**Re: Stormwater Review
58 Massasoit Ave, Sudbury, MA**

Our firm revised the plans and Stormwater Report to address the comments received in the email dated June 23, 2023 for the above captioned project. The following is a response to comments: (Response in italics)

STORMWATER MANAGEMENT REPORT

58 Massasoit Avenue
Sudbury, Massachusetts

APPENDIX – B Stormwater Recharge Calculations

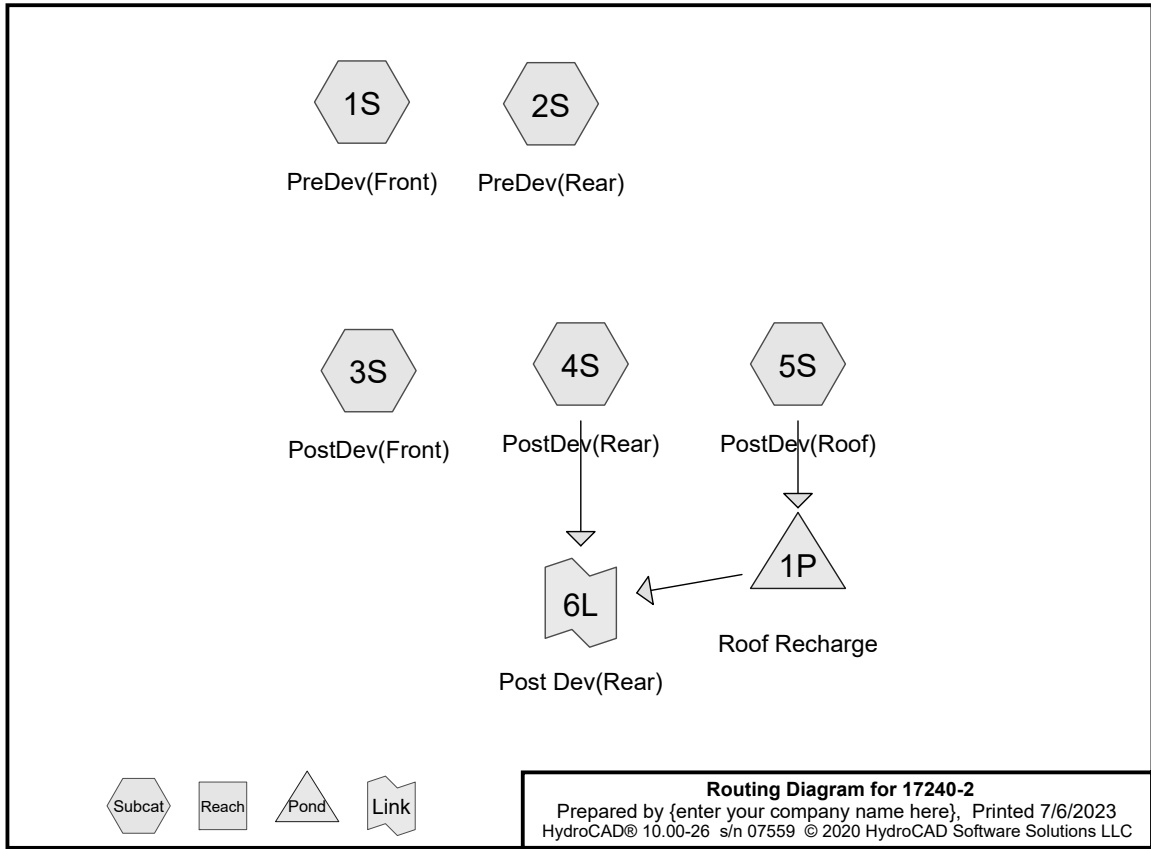
- Stormwater Recharge Calculations:
 - Total storage in chambers does not appear to be correct. Draw down calculation seems inaccurate: “K” should be for a HSG B (1.02 iph); “Rv” should be volume below outlet.
Revised Calculations See Stormwater Report Recharge Calculations.

- Time to drain/drawdown calculation for roof should use the total volume in chambers below the outlet, since there is no outlet, this would be the total volume in the system. Applicant identified 21 CF of volume; request clarification. Again, “K” value should 1.02 iph here instead of the 2.41 in/hr factor used.
Revised See Stormwater Report.

- Time to drain/drawdown calculation for driveway: again, “K” value should 1.02 iph instead of the 2.41 in/hr factor used.
Revised See Stormwater Report

Drawdown time = Volume/(K*Bottom Area)

Volume = 158 cf

K=1.02 in/hr = 0.085 ft/hr

Bottom Area = 201 sf

Drawdown time = $158 / (0.085 \text{ ft/hr} \times 201 \text{ sf})$

Drawdown time = 9.2 hr < 72 hr *ok*

JOB No. 17,240
DATE: 7/6/2022
SCALE: 1"=20'
SHEET: 1 of 3
PLAN #: 27,611

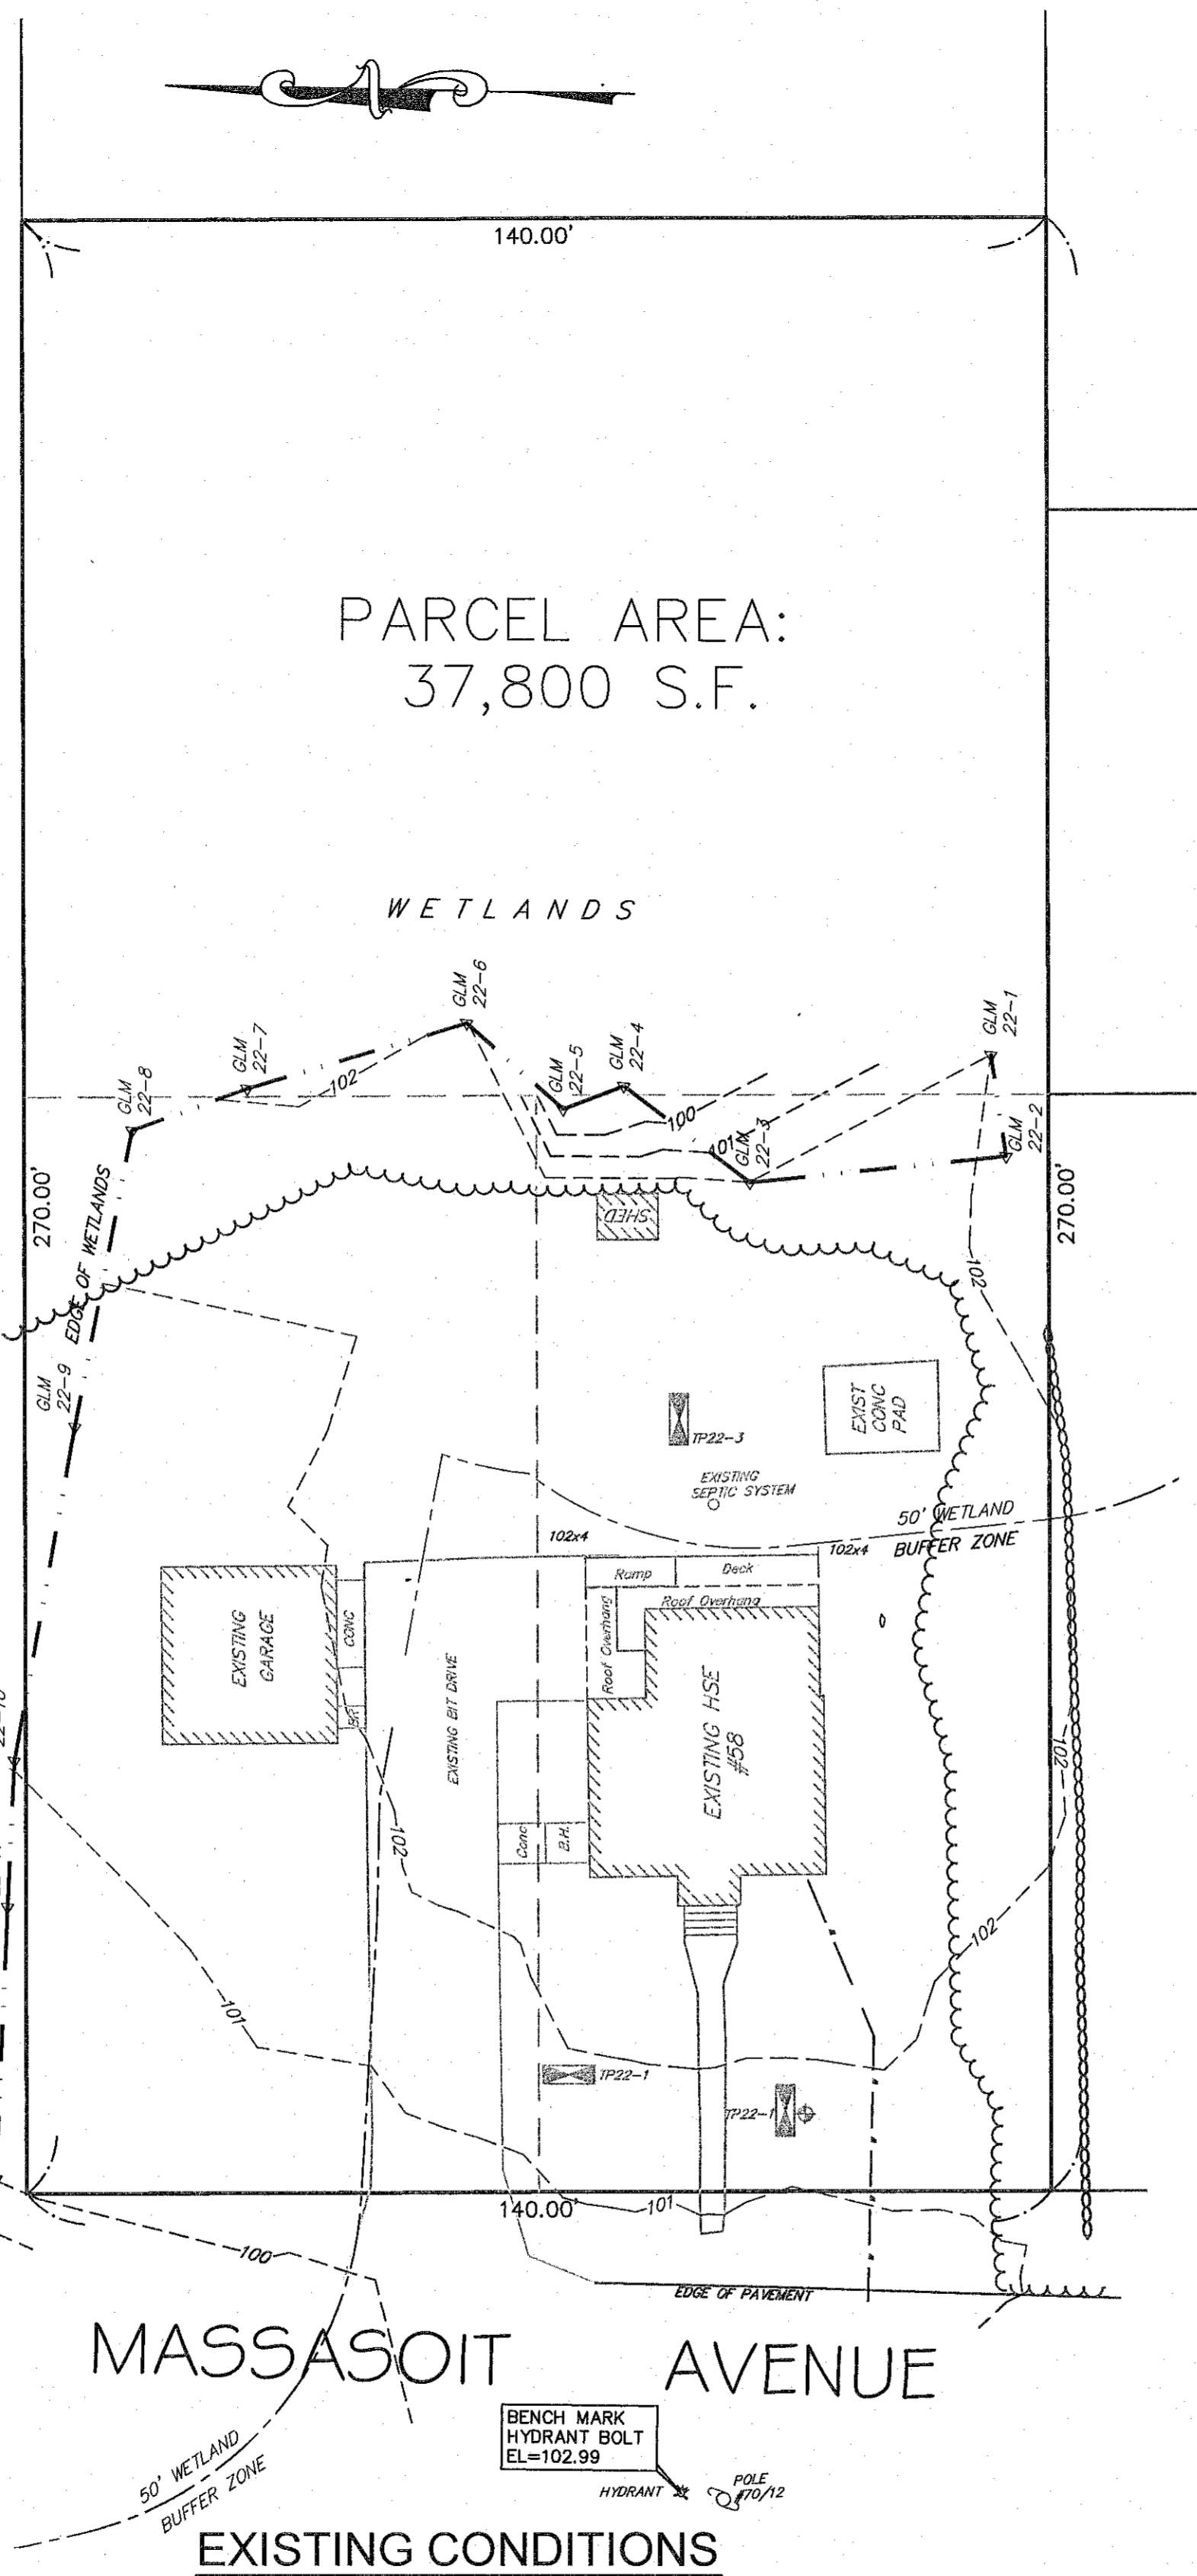
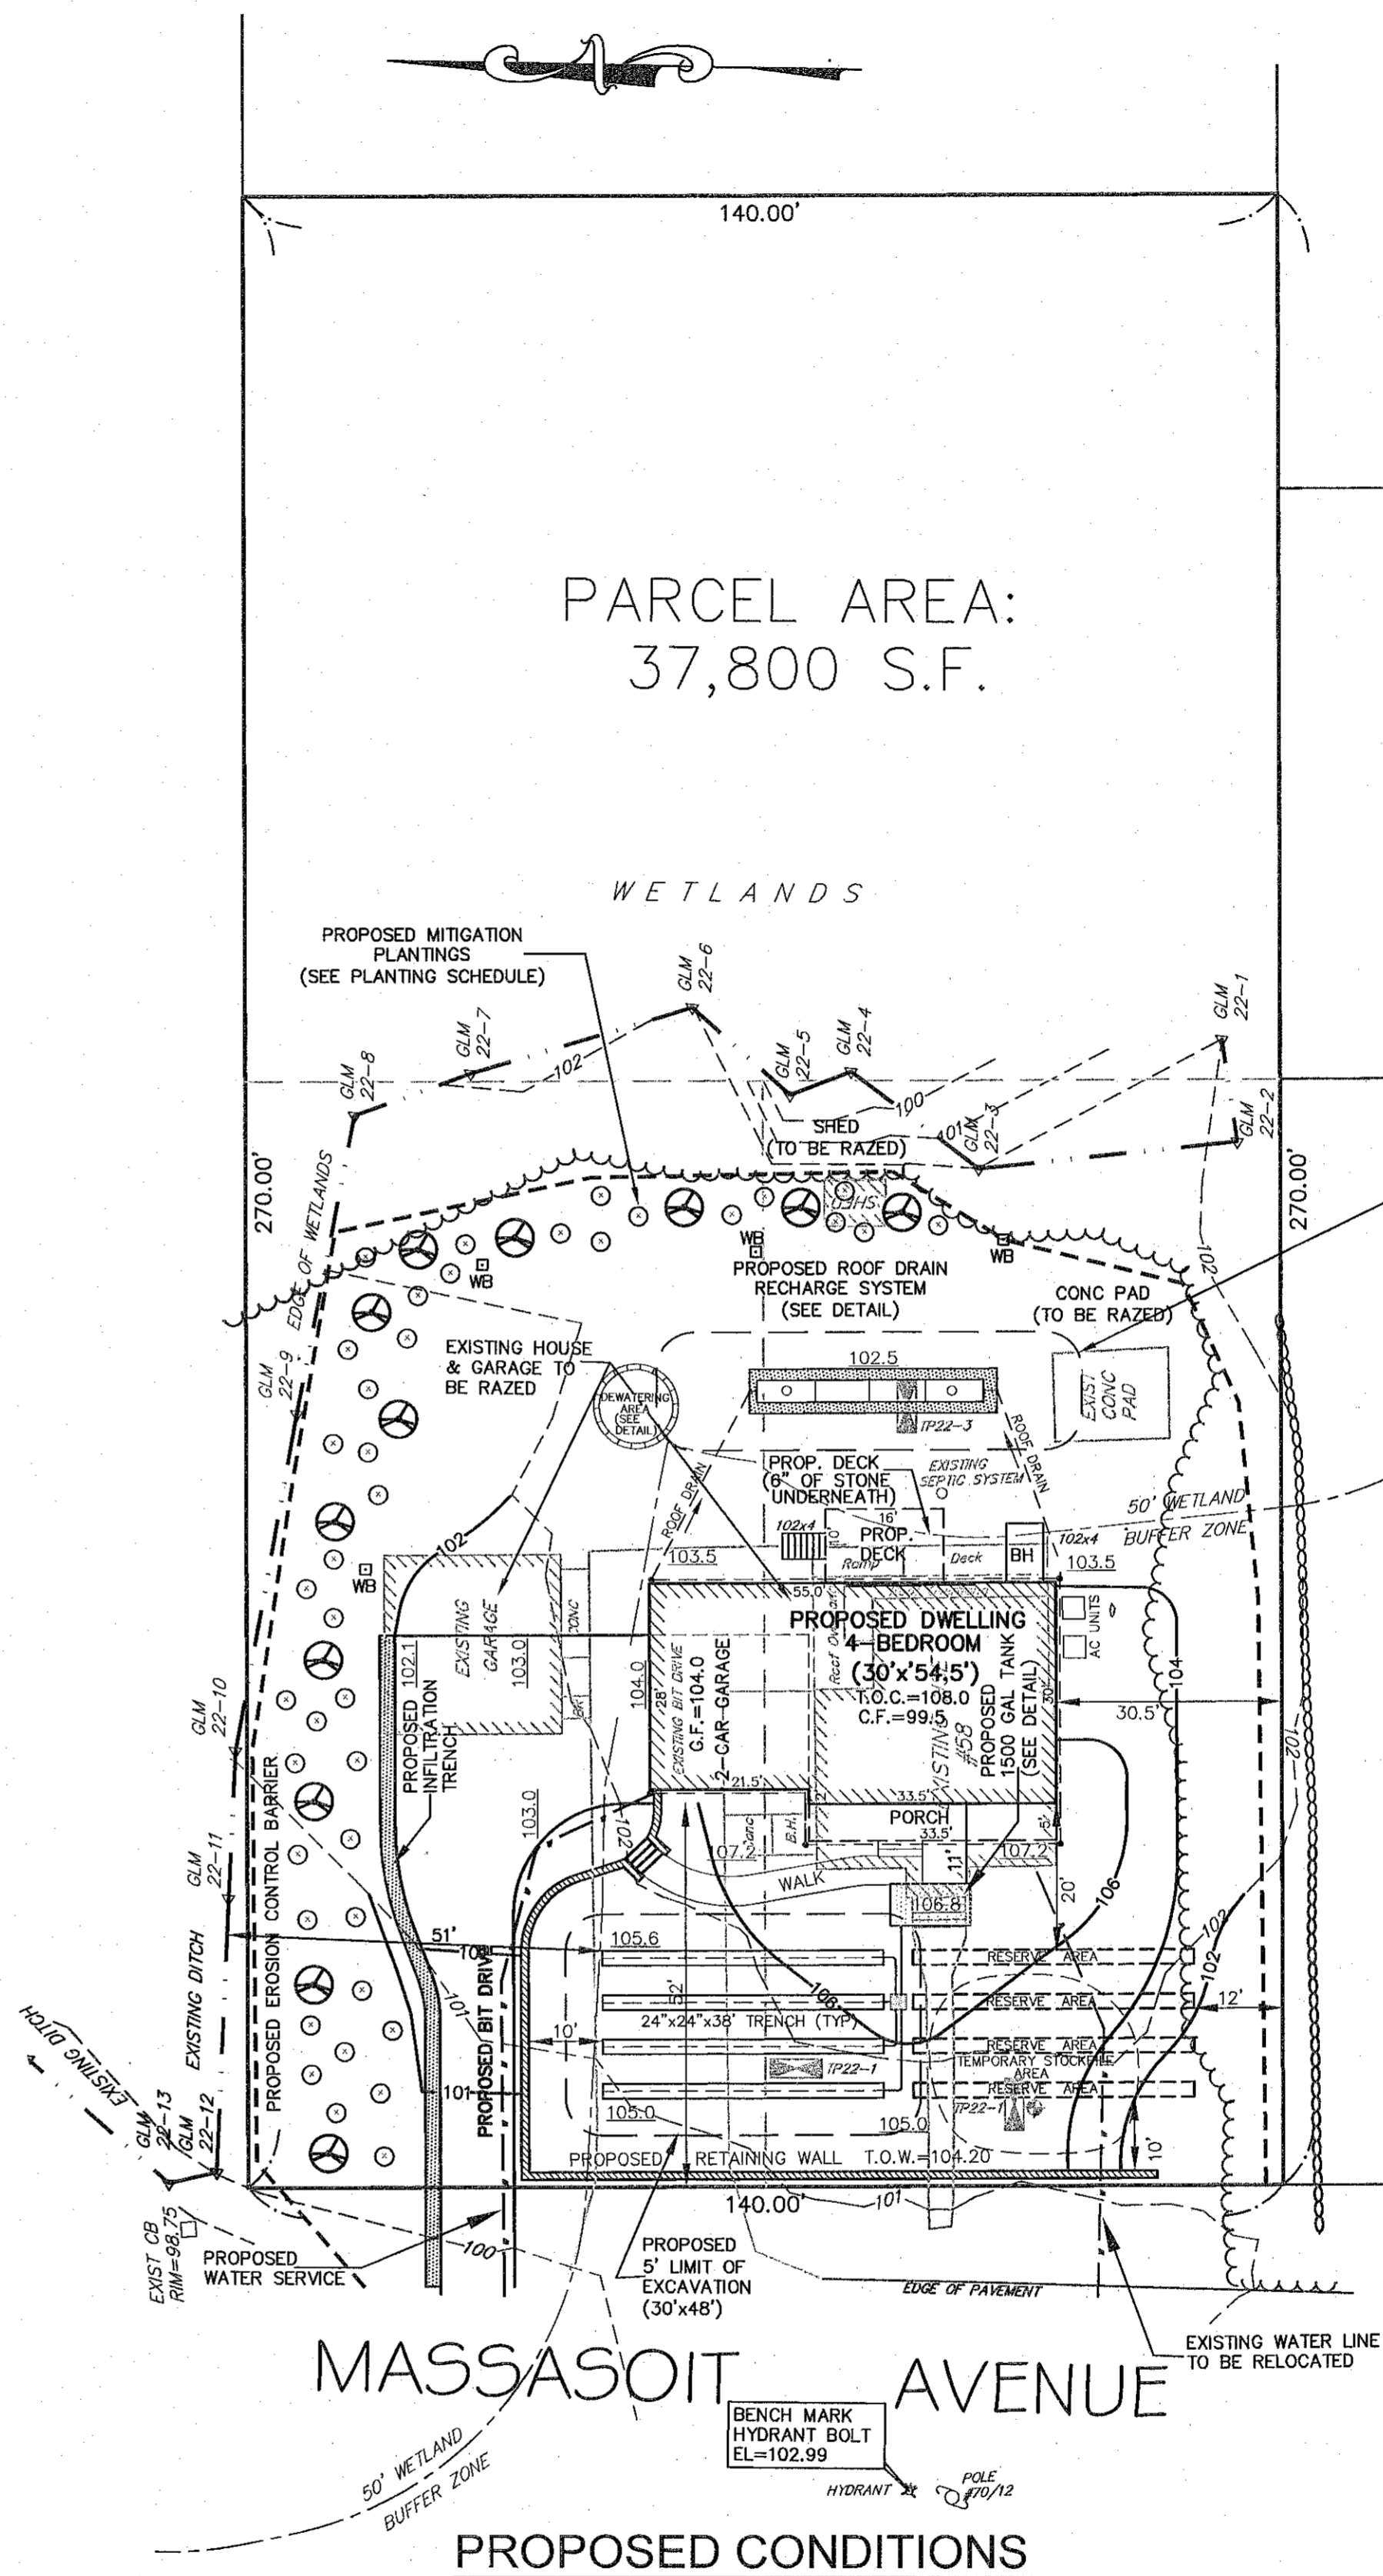
- The engineer should set the basement floor elevation above all observed ground water and staining marks as a sump pump will have no location to drain.
The basement floor has been set one (1) foot above the possible water mark. A note has been added to plan. See Sheet 1 of 3.
